SUBJECT: SEQUOYAH NUCLEAR PLANT, UNITS 1 AND 2 - ISSUANCE OF

AMENDMENT NOS. 369 AND 363 REGARDING A REVISION TO TECHNICAL

SPECIFICATIONS 3.8.1 AND 3.8.2 (EPID L-2024-LLA-0047)

# SAFETY EVALUATION BY THE OFFICE OF NUCLEAR REACTOR REGULATION AMENDMENT NO. 369 TO RENEWED FACILITY OPERATING LICENSE NO. DPR-77 AMENDMENT NO. 363 TO RENEWED FACILITY OPERATING LICENSE NO. DPR-79 SEQUOYAH NUCLEAR PLANT, UNITS 1 AND 2

#### 2.1 Offsite Power System

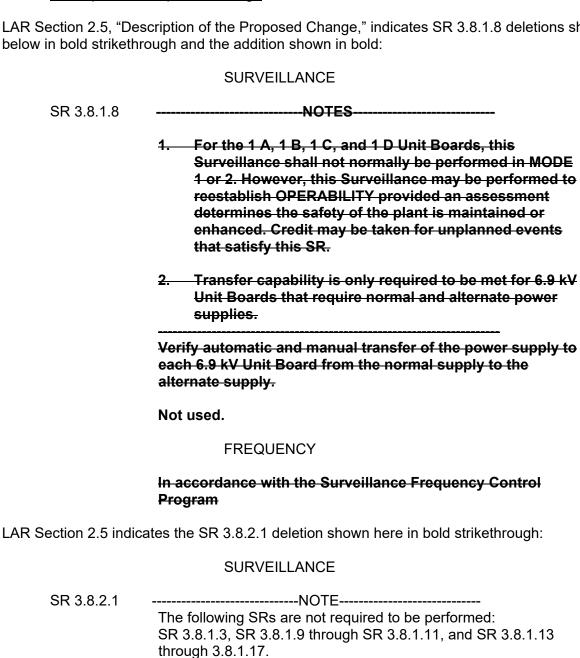
LAR Section 2.1, "System Design and Operation," states, in part, that offsite preferred electric power is supplied by two physically and electrically independent circuits; for Sequoyah Unit 1 (500-kV switchyard), and for Sequoyah Unit 2 (161-kV switchyard) through separate transformers to the onsite electrical distribution system. Under normal configuration, for a maingenerator trip, the generator circuit breaker (GCB) opens, and offsite (preferred) power is supplied from the 161-kV switchyard (for Unit 2) or from the 500-kV switchyard (for Unit 1) through the Unit Station Service Transformers (USSTs) to the 6.9-kV Unit Boards. Power is then routed by two independent circuits from the 6.9-kV Boards to the 6.9-kV Shutdown Boards for each unit.
